Flooding and Hydrology Plan

A sub plan of the Operational Environmental Management Plan.

SMCSWTS2-MTS-1NL-EM-PLN-002711

Figure 20: Marrickville Dive Site PMF Diagram

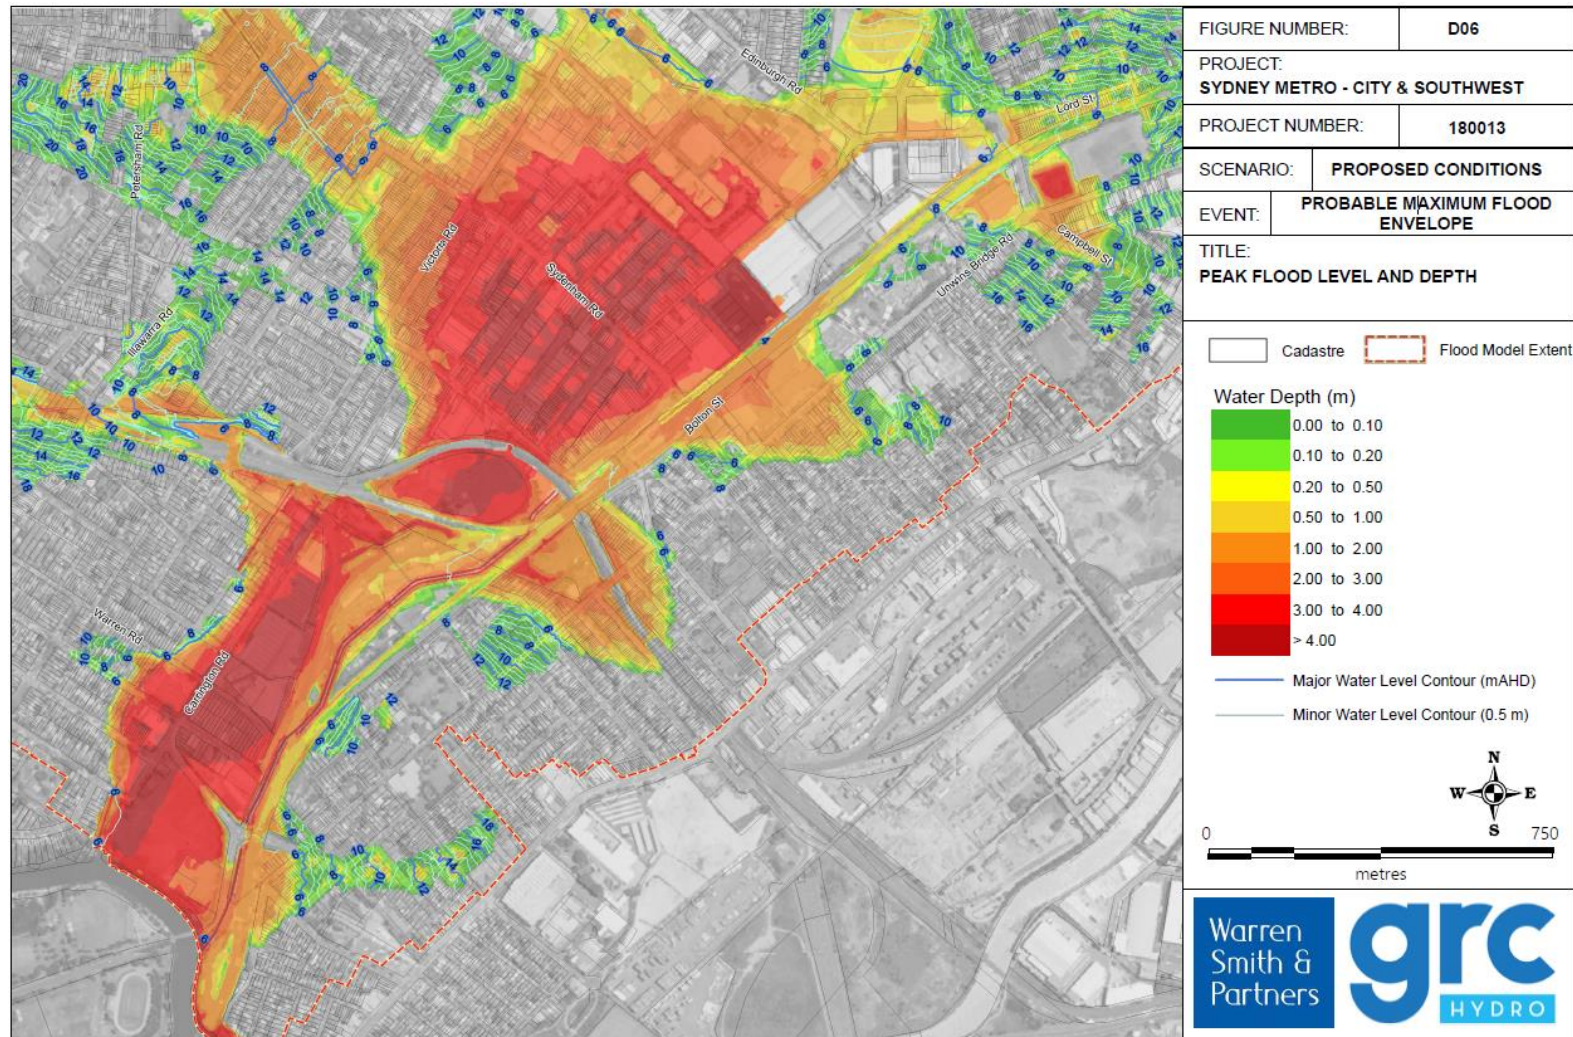
Inner West Council	The table provides a lengthy description of the flood behaviour in and around the dive site. It would be useful if the Plan was supported by flood mapping to more clearly illustrate this flood behaviour.	Flood mapping now included in Section 4.2.3. Updated in v2 of the FHMP.	Closed - Inner West stated they would endorse the plan once the Marrickville Dive Site's Probable Maximum Flood map has been updated in the FHMP. Page 37 now has the updated Probable Maximum Flood map that was required by Inner West Council.

As per the below screenshot, the PMF map for the Marrickville Dive Site shows the 100 year ARI event change map rather than the PMF extent and hazard categories.

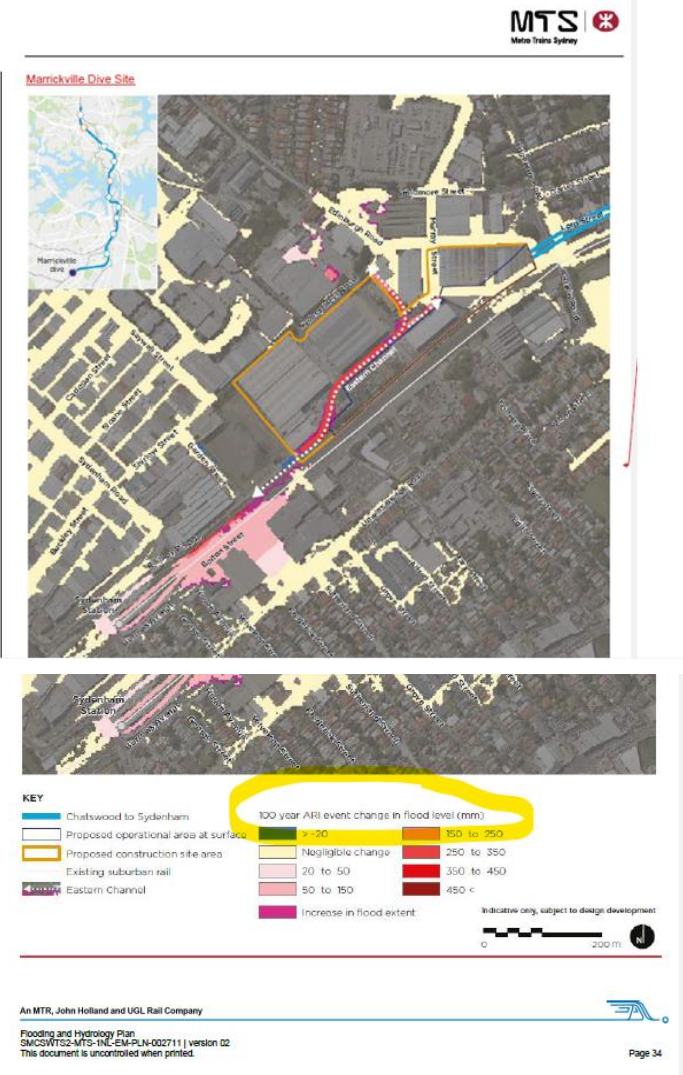
We are happy with the changes made on the last version, except that there appears to be an error with one of the figures added to the document.

We are happy to endorse the Plan once this map is corrected.
